INDESIT company

Model type:
WISL85XEX

Commercial code:
F030564

N1040319FIG1

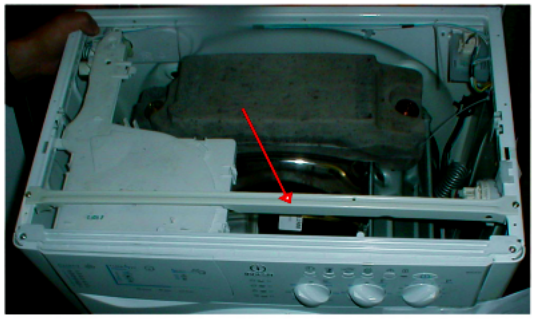
n1040319: Elimination of metal bar on INDESIT cabinets.

From serial no. 40223.0001 Indesit EVOII Washing Machines produced in the Comunanza - Brembate factory have been equipped with a wooden reinforcing strip on the top, whereas the metal bar on the cabinet has been eliminated.

The modified tops have the same Service code as premodification items (096937, 097617, 098440, 099929 and 097806).
When using the new top on a premodification appliance the metal bar (see N1040319FIG1) must be removed, whereas the old top can be used in place of the new one without any modification.
The new top can be used in place of the old one and vice versa; the Service code remains the same.

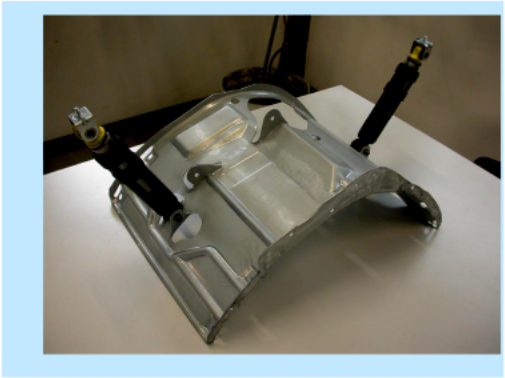
n1040325: New shock absorber fixing system with pin

From serial no. 40427.0001, shock absorbers have been fixed to the tank unit cradle with two 11 mm pins code C00110163 (see fig. 01 and 02 enclosed) in place of the 8 mm screws code 093750 and relevant locking nuts code 030443, on all washing machines and dryers produced in the Comunanza factory.
The items affected by this modification are:
1) The cradles have the same Service code, as they can be used in place of the new ones after widening the shock absorber fixing holes to a diameter of 10 mm.
Code 093848 - Tank unit cradle 46 lt
Code 093878 - Tank unit cradle 40 lt.

2) The new shock absorbers, with fixing bushing having no s/steel spacer, are not managed as they are interchangeable with the premodified items (make sure they are CIMA type, as the managed items), fixed with M8 screws code 093750 and related locking nut code 030443 (see figs. 05 and 06).
Code 093884 - Shock absorber 80 N
Code 093885 - Shock absorber 100 N

To remove the shock absorber from the tank, first extract the pin with a few hammer taps (see fig.03) until it is aligned with the tank bracket and then pull it out with a pair of pliers (see fig. 04).
(To refit the shock absorber use a new pin. Insert the pin until the toroidal edge is aligned with the bracket.)

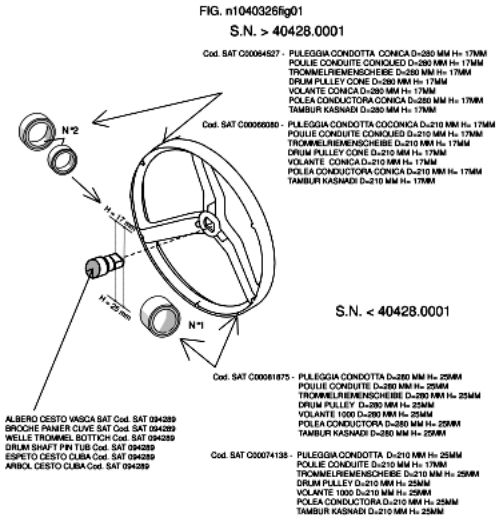
n1040326: Two-bearing mechanism on Slim range washing machines

From serial no. 40428.0001, all Slim range models produced in the Comunanza factory have been equipped with a two-bearing mechanism in place of the single-bearing one.

The Service codes of the new mechanism are:
Service code C00096186 - SEAL RING CV4;
Service code C00002591 - BEARING 20X47X14 6204 SKF;
Service code C00013563 - BEARING 25 X52 X 15 6205 - 2Z SKF;
Service code C00110340 - CROSS WITH SEAL RING (2C) SNELLA;
Service code C00094289 - EVO 40L TANK SLIM (1-C) > (2-C)EVOII;
Service code C00094290 - OUTER- SET 40 L.(1-C)>(2-C)EVOII;
Service code C00064527 - DRIVEN PULLEY CONE D=280 MM H= 17MM;
Service code C00066080 - DRIVEN PULLEY CONE D= 210 MM H=17 MM.

The tank assembly with the new two-bearing cross has the same Service code as the single-bearing one (C00094289); the latter will be available until stocks run out.
When replacing the tank, make sure that the value H (17 mm or 25 mm) of the basket cross shaft corresponds to the value H of the pulley (see Fig.001).

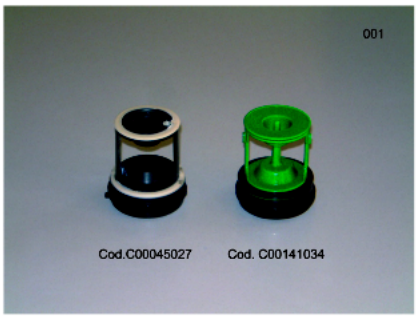
n1040359: Polar White Factory 80 (Comunanza)

From serial no. 50315.0001, the new "Polar White" colour is used on all washing machines and washer-dryers produced in factory 80 in place of White 27.
The third last number of the Industrial Code given on the rating plate of the modified models is 9 (e.g. 80286390900).
To determine the new Polar White codes, it is necessary to know the industrial code or serial number of the appliance being repaired.
The new items, which bear the initials "PW" in place of "B27", are not aesthetically interchangeable with premodification items as the whites are different. Both colours will be available for some time.
The items affected by this modification are:
Body, rear panel, top, control panel, handles, buttons, knobs, knob disc, door and plinth.
